DEPARTMENT OF TRANSPORTATION

Contract #: 04-0120F4Cty: SF/ALA Rte: 80 PM: 13.2/13.9File #: 69.25B

QUALITY ASSURANCE -- NON-CONFORMANCE REPORT

Welding	Concrete	Other	
Welding	Curing	Procedural	Bridge No: 34-0006
Joint fit-up	Coating	Other	Component: Segment 11DE
Procedural	Procedural	Description: Missed MT crack and UT indications by QC

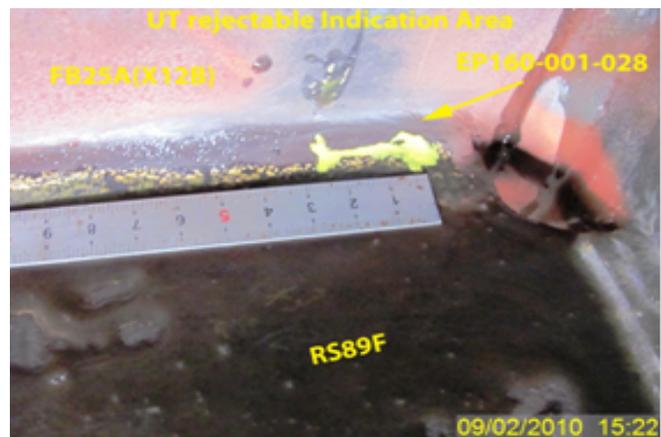
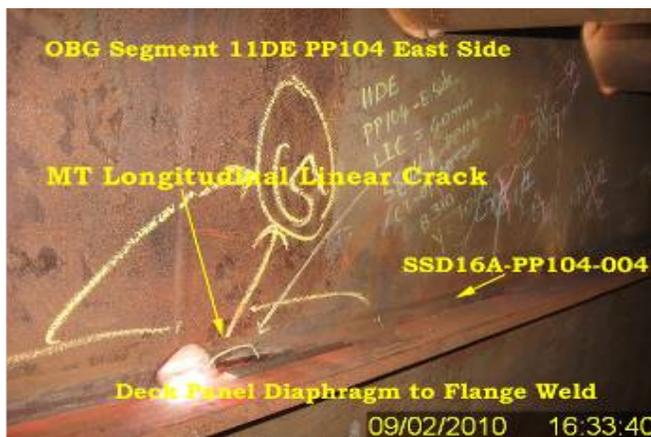
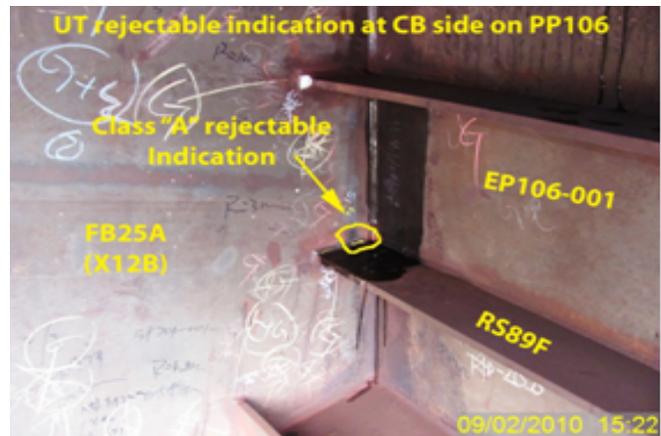
During the Quality Assurance (QA) Ultrasonic Testing (UT) review of welds located on Orthotropic Box Girder (OBG) segment 11DE, this QA Inspector discovered the following issues:

- A total of four (4) longitudinal class "A" rejectable indications measuring approximately 15mm~25mm in length.
- The welds are identified as SEG072A-002, SEG072A-008, SEG072B-055 and EP160-001-028.

- Material thickness for joints SEG072A-002, 008 is 16mm.
- Material thickness for joint SEG072B-055 is 18mm.
- Material thickness for joint EP160-001-028 is 12mm.

- The indication dB rating for joint SEG072A-002 is a +9 and for joint SEG072A-008 is a +4.
- The indication dB rating for joint SEG072B-055 is +9.
- The indication dB rating for joint EP160-001-028 is +3.

- The depth of the indications are approximately 9mm~15mm.
- Welds SEG072A-002, SEG072A-008 are joining Side Plate to Side plate and EP160-001-028 is at PP106, joining Edge Plate stiffener to corner assembly Diaphragm.

- Weld SEG072B-055 is at panel point PP105 joining Floor beam FB24A to Longitudinal diaphragm stiffener.
- Welds SEG072A-002 and SEG072A-008 are Complete Joint Penetration (CJP) butt joints.

- Weld SEG072B-055 and EP160-001-028 are Complete Joint Penetration (CJP) "T" joints.
- The Y distance for joint SEG072A-002 is 2100 from panel point PP106.

- The Y distance for joint SEG072A-008 is 1370mm from panel point PP106.
- The Y distance for joint SEG072B-055 is 10mm from cope hole.
- The Y distance for joint EP160-001-028 is 35mm from cope hole.

- These welds are designated as Seismic Performance Critical Members (SPCM).
- The indications are clearly marked on or near the weld.
- Segment 11DE is located north of fabrication Bay#14.

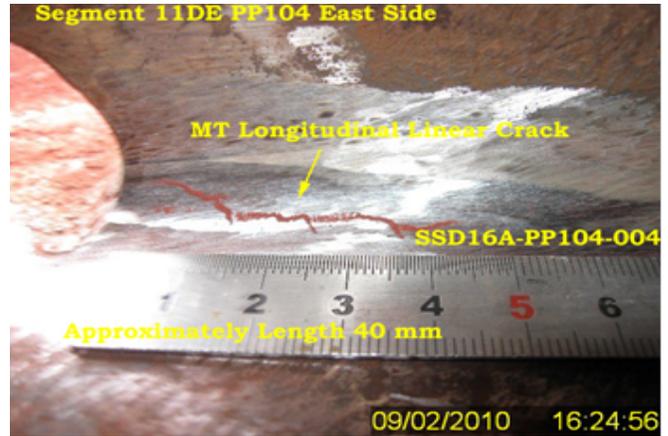
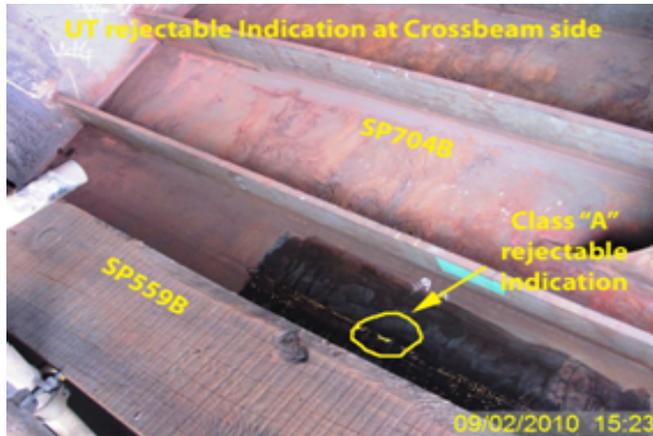
During the Quality Assurance (QA) Magnetic Particle Testing (MT) review of welds located on Segment 11DE, this QA Inspector discovered the following issue:

- One (1) MT Longitudinal Linear Crack measuring approximately 40 mm in length.
- The weld is identified as SSD16A-PP104-004 and is located at panel point (PP) 104 East side.
- This weld is a fillet weld that joins the Deck Panel Diaphragm to the Web flange.
- Y location is 7040mm measured from the termination of the weld on the Cross Beam side.
- The Linear Crack is clearly marked on the material near the weld.
- The Deck Panel Diaphragm and Flange weld are identified as Non Seismic Performance Critical Members (Non-SPCM).
- OBG segment 11DE is located outside at the north end of Bay 14.

The Notice of Witness Inspection Number (NWIT) is 006556. This Linear Crack is located within an area that has been previously tested by ZPMC Quality Control (QC) personnel. As per contract documents ZPMC is required to perform 100% Magnetic Particle Testing (MT) of this weld.

WELD NUMBER: SEG072A-008

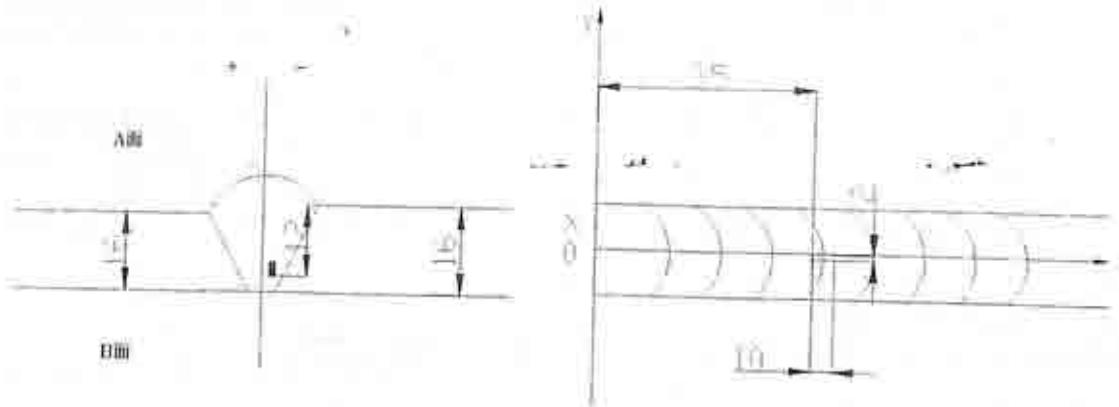
(Description of welding discontinuity): Rejected indication found by ultrasonic inspection is less than the maximum allowance aggregate length.

1. 焊道未及时处理干净。
1. Did not clear the weld pass completely in time.

1. 从缺陷距离端面较近一侧 ($D \leq 0.65T$, D 为缺陷深度, T 为板厚) 采用碳刨或打磨的方法去除焊缝缺陷;
 2. 参照返修焊接工艺规程 (WPS) 准备正确的接头型式, 预热和焊接;
 3. 将修补区域打磨到与母材或邻近焊缝平齐;
 4. 根据批准的车间图纸检查焊缝.
-
1. Gouge or grind from nearer side from metal edge. ($D \leq 0.65T$, "D" is depth of defects, "T" is thickness of metal) to remove all defects;
 2. Follow repair WPS for joint preparation, preheat, and weld deposit;
 3. Grind the repaired area flush with base metal or the adjacent weld;
 4. Check the welds according to the working drawings.

WELD NUMBER: SEG072A-002

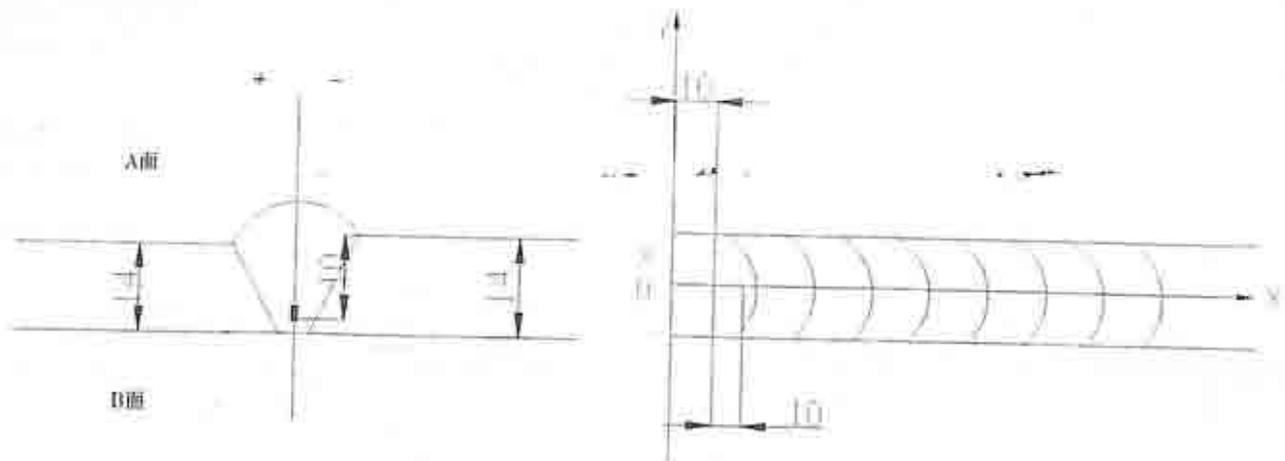
(Description of welding discontinuity): Rejected indication found by ultrasonic inspection is less than the maximum allowance aggregate length.

1. Did not clear the weld pass completely in time.

1. Gouge or grind from nearer side from metal edge ($D \leq 0.65T$, "D" is depth of defects, "T" is thickness of metal) to remove all defects;
2. Follow repair WPS for joint preparation, preheat, and weld deposit;
3. Grind the repaired area flush with base metal or the adjacent weld;
4. Check the welds according to the working drawings.

WELD NUMBER: SEG072B-055

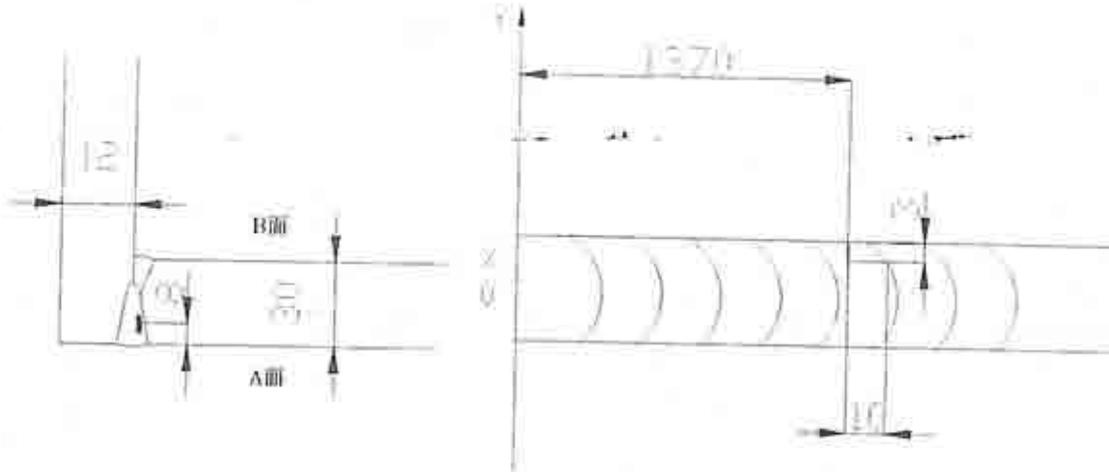
(Description of welding discontinuity): Rejected indication found by ultrasonic inspection is less than the maximum allowance aggregate length.

1. 焊道未及时处理干净。
1. Did not clear the weld pass completely in time.

1. 从缺陷距离端面较近一侧 ($D \leq 0.65T$, D 为缺陷深度, T 为板厚) 采用碳刨或打磨的方法去除焊缝缺陷;
 2. 参照返修焊接工艺规程 (WPS) 准备正确的接头型式, 预热和焊接;
 3. 将修补区域打磨到与母材或邻近焊缝平齐;
 4. 根据批准的车间图纸检查焊缝.
-
1. Gouge or grind from nearer side from metal edge ($D \leq 0.65T$; "D" is depth of defects, "T" is thickness of metal) to remove all defects;
 2. Follow repair WPS for joint preparation, preheat, and weld deposit;
 3. Grind the repaired area flush with base metal or the adjacent weld;
 4. Check the welds according to the working drawings.

WELD NUMBER: EP160-001-028

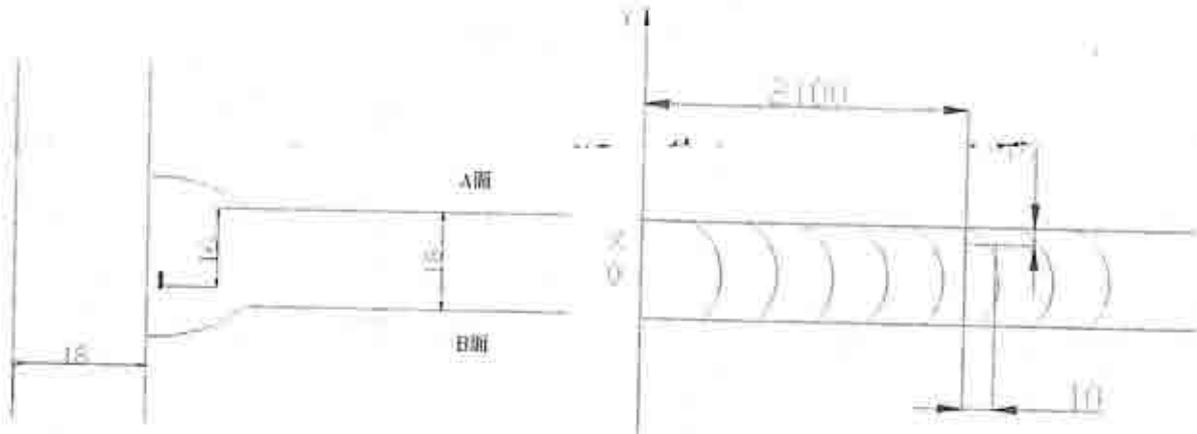
(Description of welding discontinuity): Rejected indication found by ultrasonic inspection is less than the maximum allowance aggregate length.

1. Did not clear the weld pass completely in time.

1. Gouge or grind from nearer side from metal edge ($D \leq 0.65T$, "D" is depth of defects, "T" is thickness of metal) to remove all defects;
2. Follow repair WPS for joint preparation, preheat, and weld deposit;
3. Grind the repaired area flush with base metal or the adjacent weld;
4. Check the welds according to the working drawings.
